ADDENDUM NO. 1

FOR: **OZARK COUNTY BRIDGE REPLACEMENT**
BRIDGE 01500251
GRA NO. 13-3136

This addendum is issued due to the change in slab beam dimensions, from 27" to 23". The sheets below have been revised for the 23" beam.

SHEET NUMBER:
C4

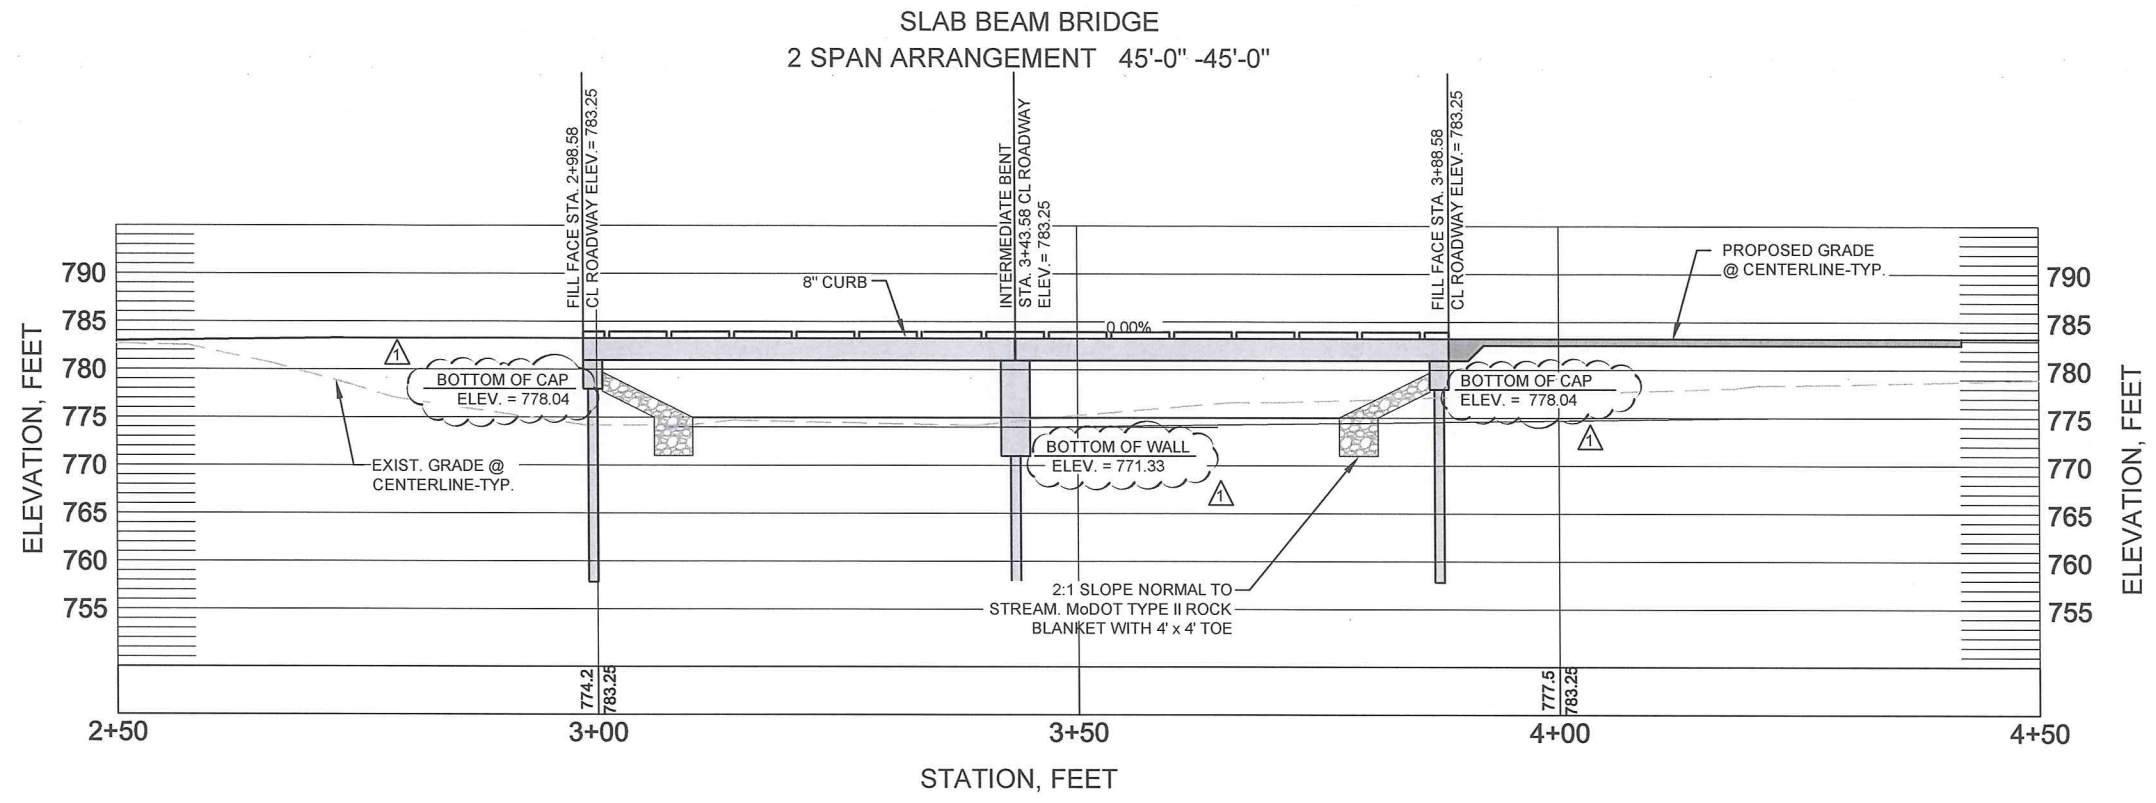
On the Construction Plans sheet C4, under bridge quantities reinforcing steel (substructure) has changed to 4,981 lbs.

CHECKED BY: SJ
DRAWN BY: KFT
JOB NUMBER: 12-3136
FILE NAME: 12-3136_CIVIL.DWG
SCALE: NOTED
ISSUE DATE: 10-03-2013
SHEET NUMBER: C8

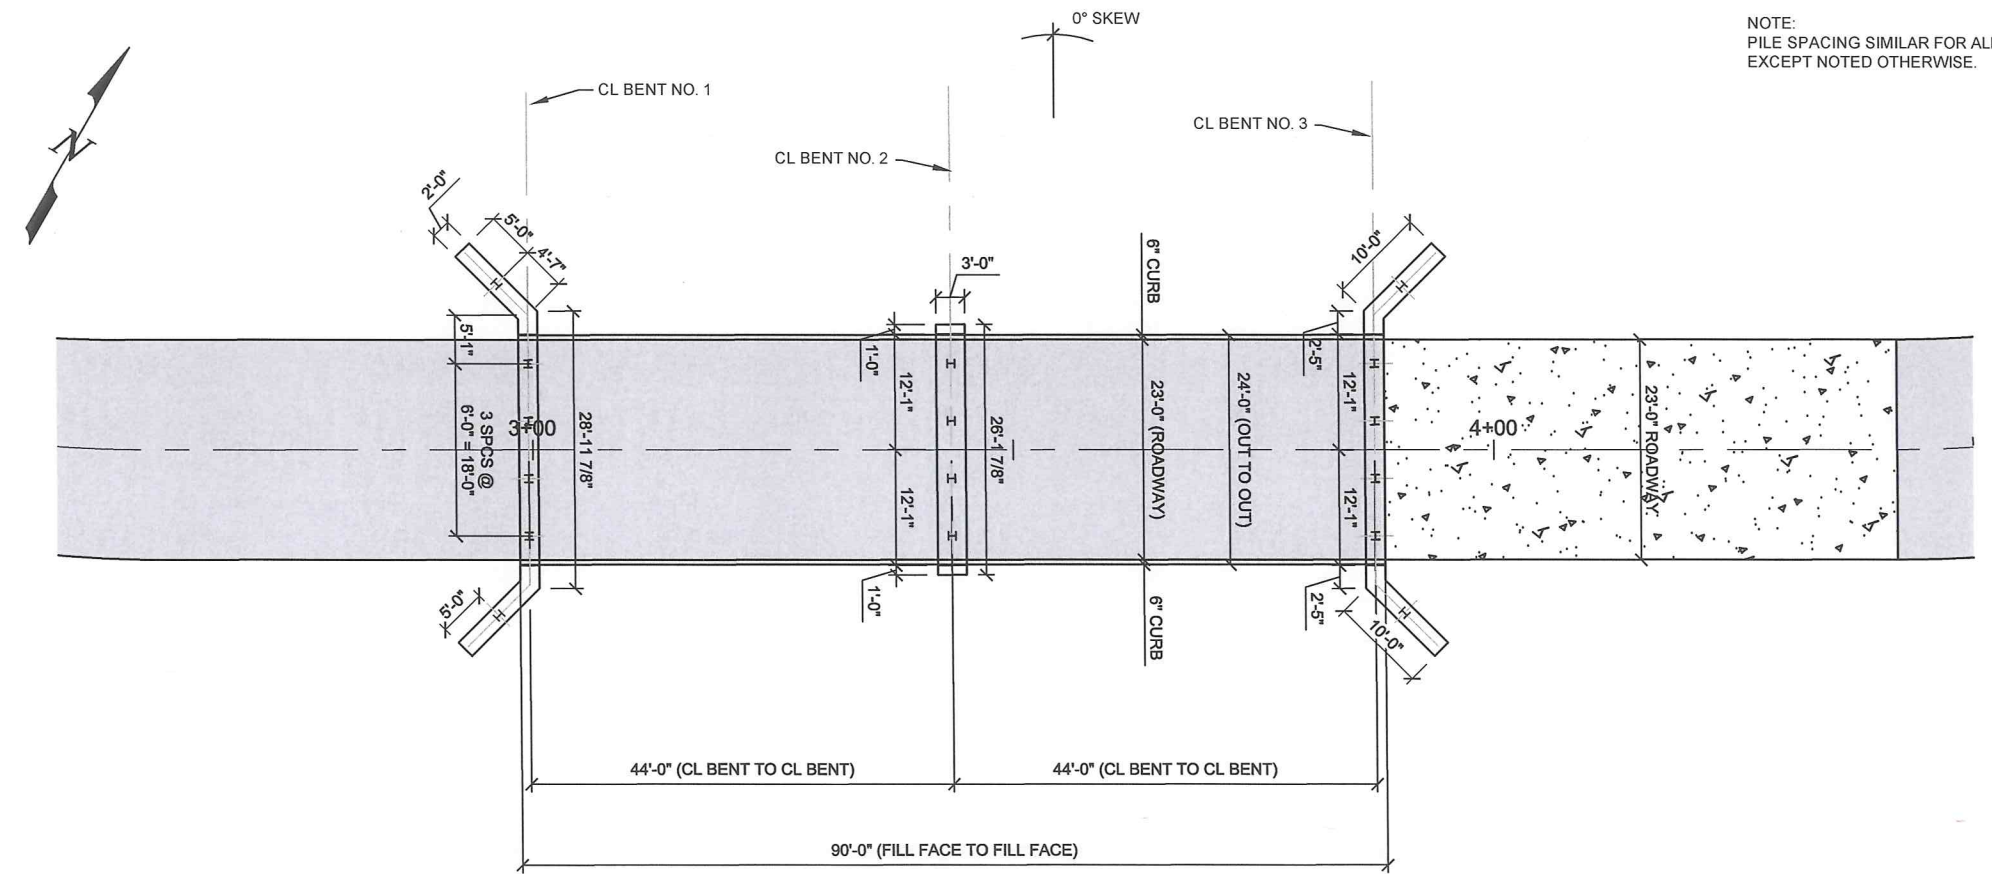
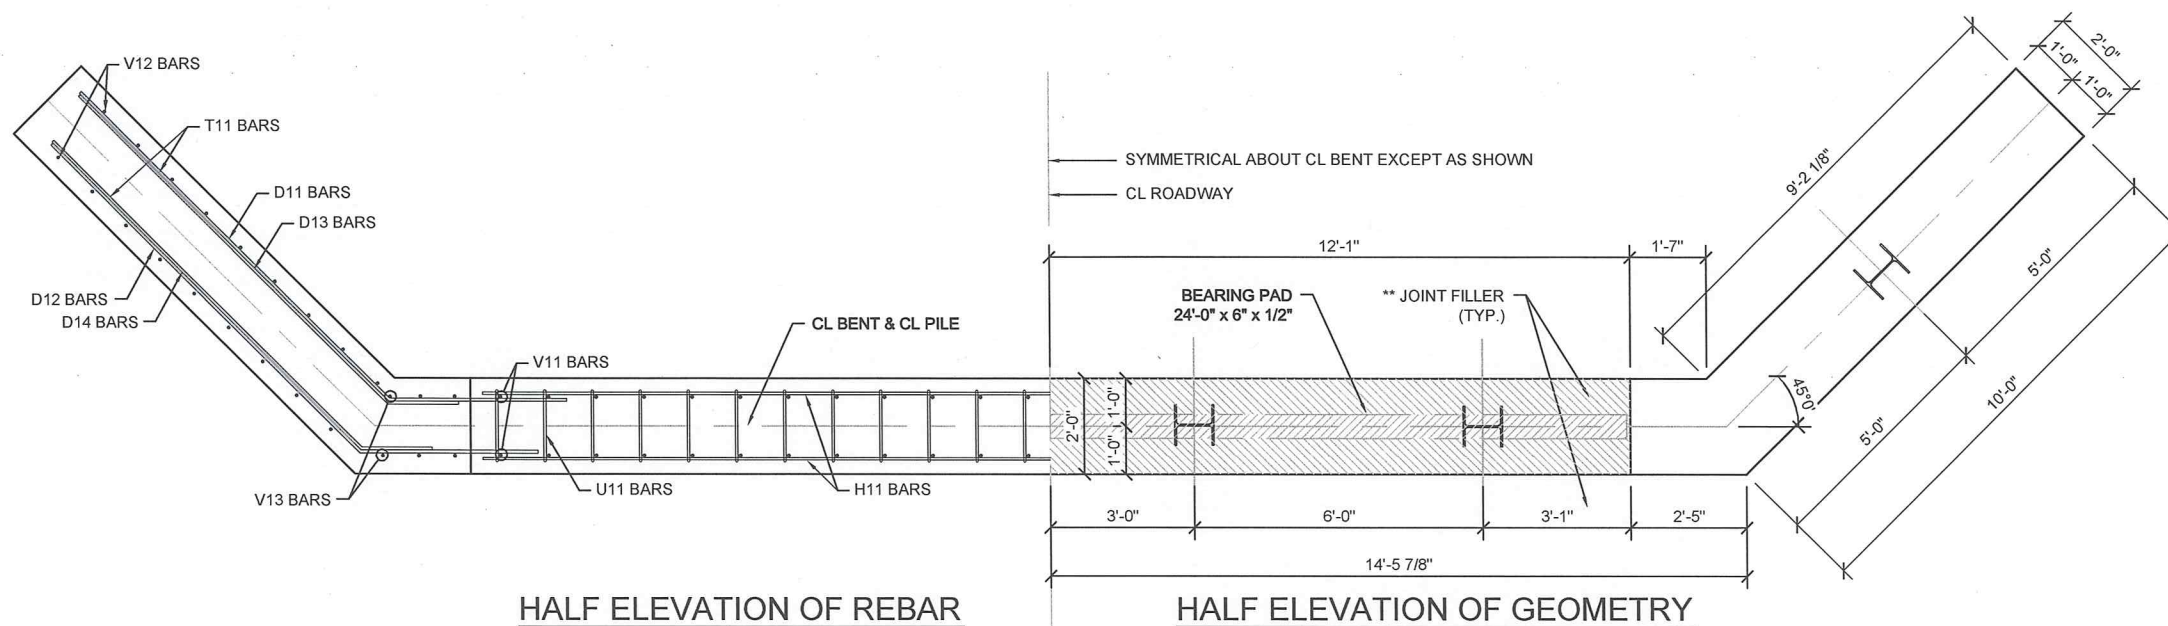
On the Construction Plans sheet C8, the bottom of cap elevation has changed to 778.04 and the bottom of wall elevation has changed to 771.33

CHECKED BY: SJ
DRAWN BY: KFT
JOB NUMBER: 12-3136
FILE NAME: 12-3136_Structural
SCALE: NTS
ISSUE DATE: 10-03-2013
SHEET NUMBER: **S1**

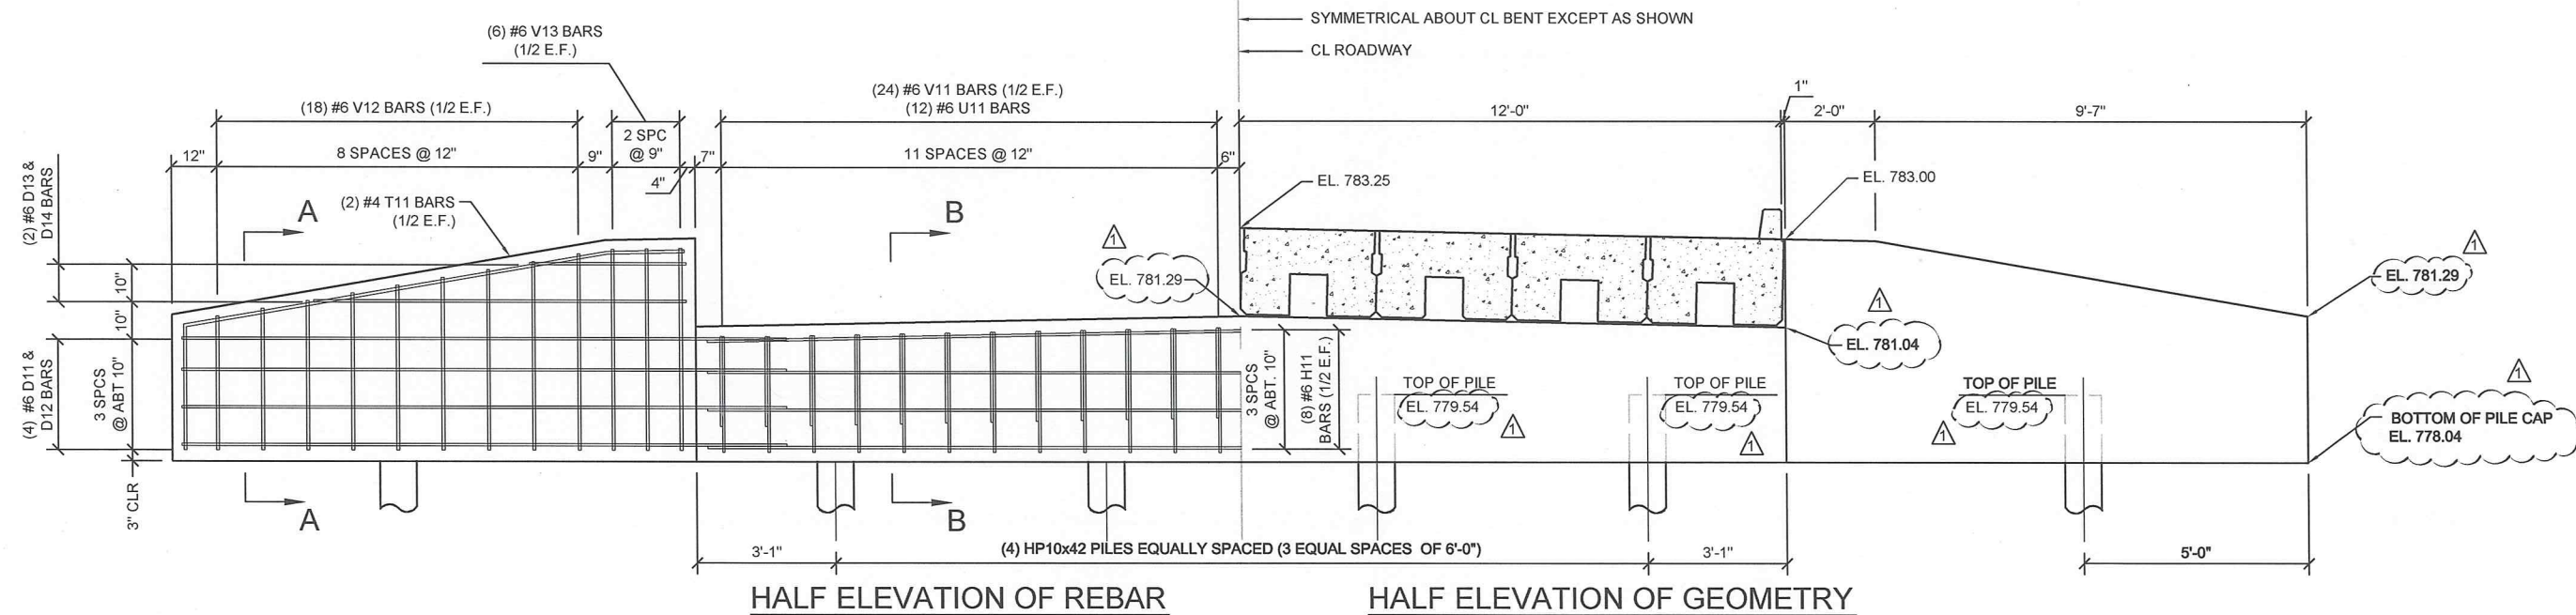
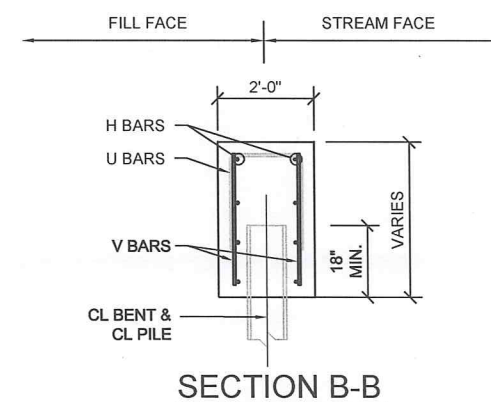
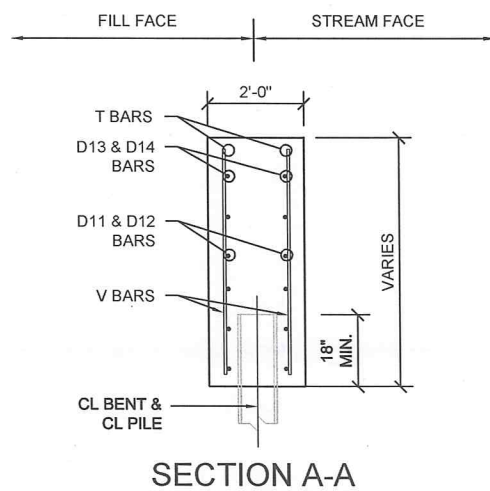
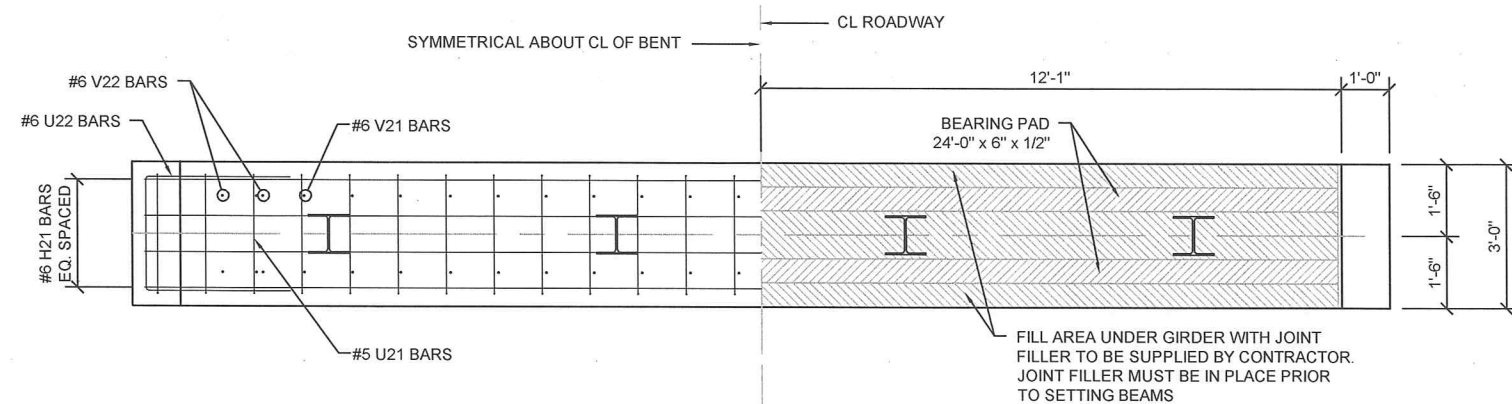
On the Construction Plans page s1, the elevation of Top of Pile has changed to 779.54, the bottom of pile cap has changed to 778.04, the elevation of the top of wing wall is 781.29, and the elevation of the crown of the cap is 781.29.

S2

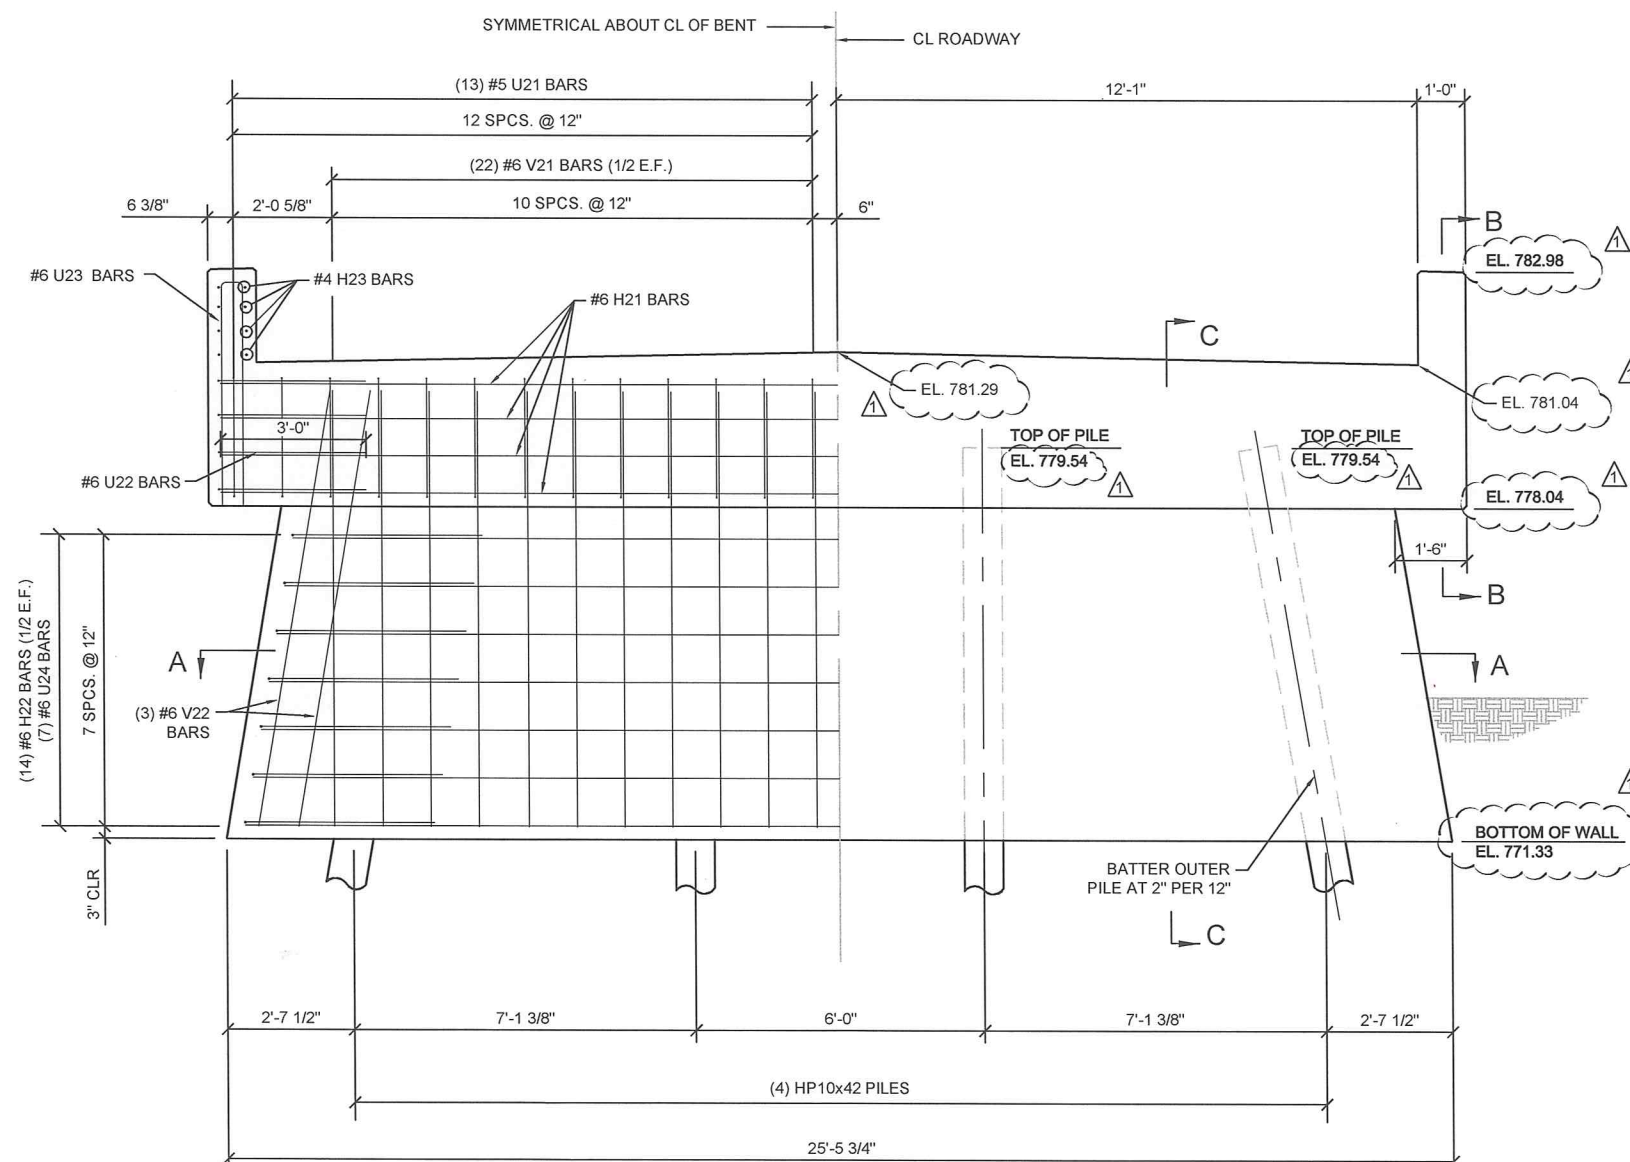
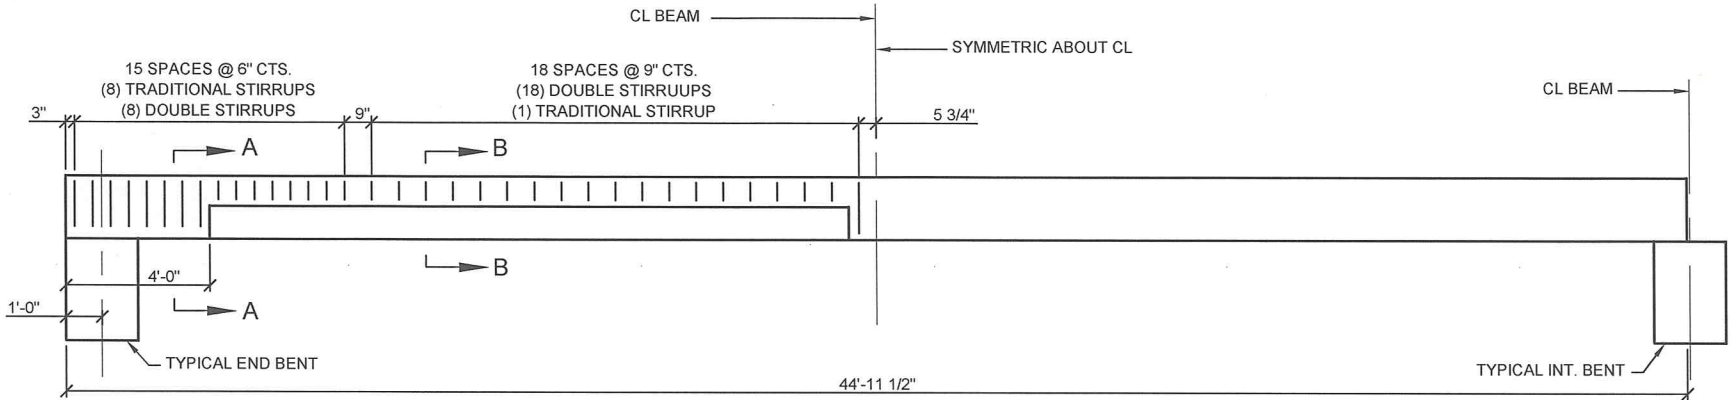
On the Construction Plans sheet S2, elevations have changed.
